Developer Services
Southern Water
Sparrowgrove House
Sparrowgrove
Otterbourne
Hampshire
SO21 2SW

M/43/15/PL

Proposal: Demolition of existing bungalow, detached garage & greenhouse & erection of 1 No dwelling, garage & garden shed (resubmission following M/24/14/PL).
Site: 6 Alleyne Way, Eimer, Middleton-on-Sea, PO22 6JZ.
M/43/15/PL

Southern Water MapGuide Browser

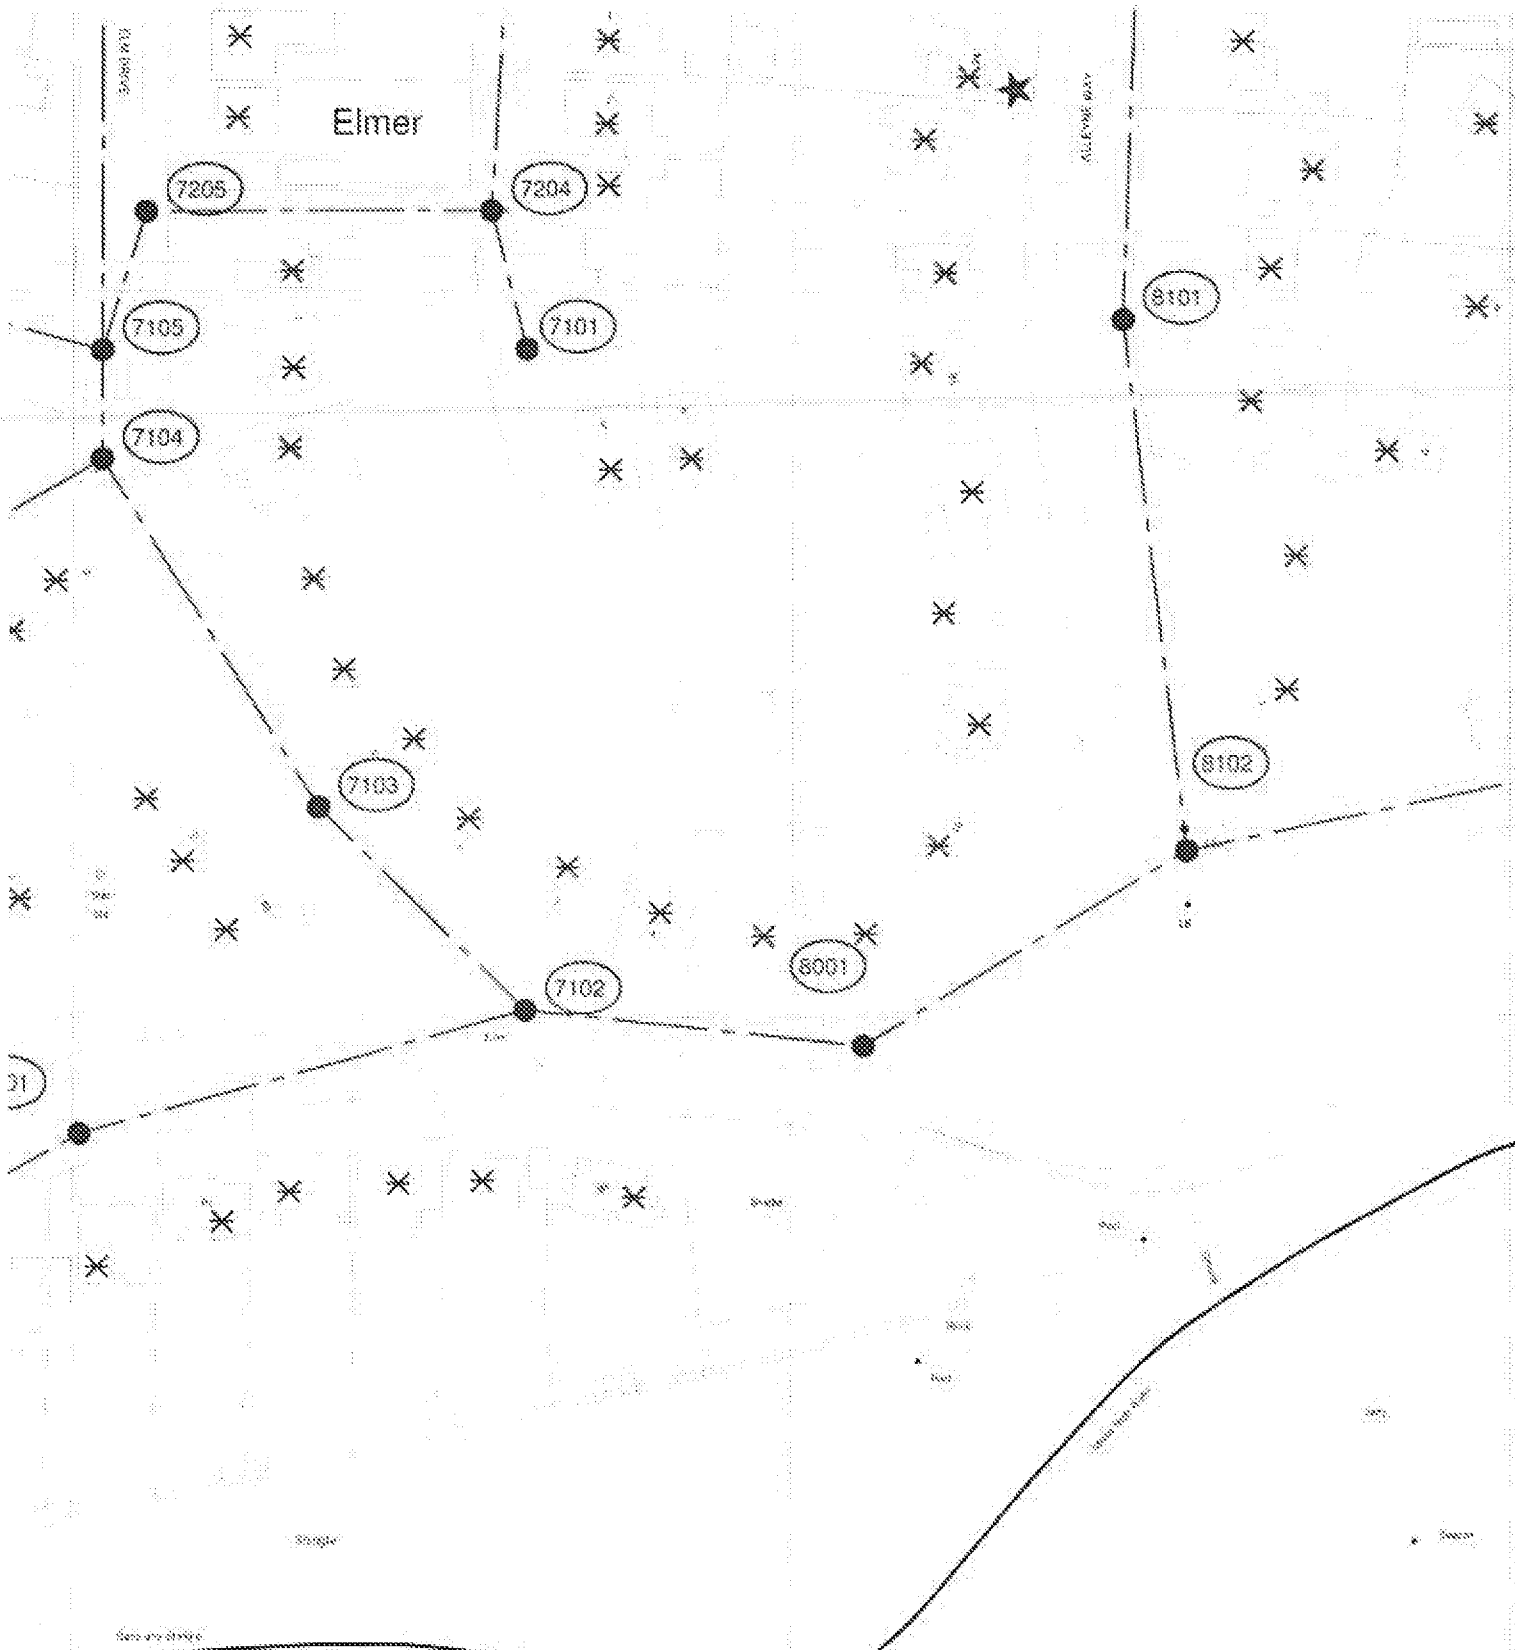
Our initial investigations indicate that there are no public surface water sewers in the area to serve this development. Alternative means of draining surface water from this development are required. This should not involve disposal to a public foul sewer.

Due to changes in legislation that came in to force on 1st October 2011 regarding the future ownership of sewers it is possible that a sewer now deemed to be public could be crossing the above property. Therefore, should any sewer be found during construction works, an investigation of the sewer will be required to ascertain its condition, the number of properties served, and potential means of access before any further works commence on site.

The position of pipes shown on this plan are believed to be correct. But Southern Water Services Ltd accept no responsibility for the extent of inaccuracy. The actual positions should be determined on site.

WARNING: BAC pipes are constructed of Banded Asbestos Cement
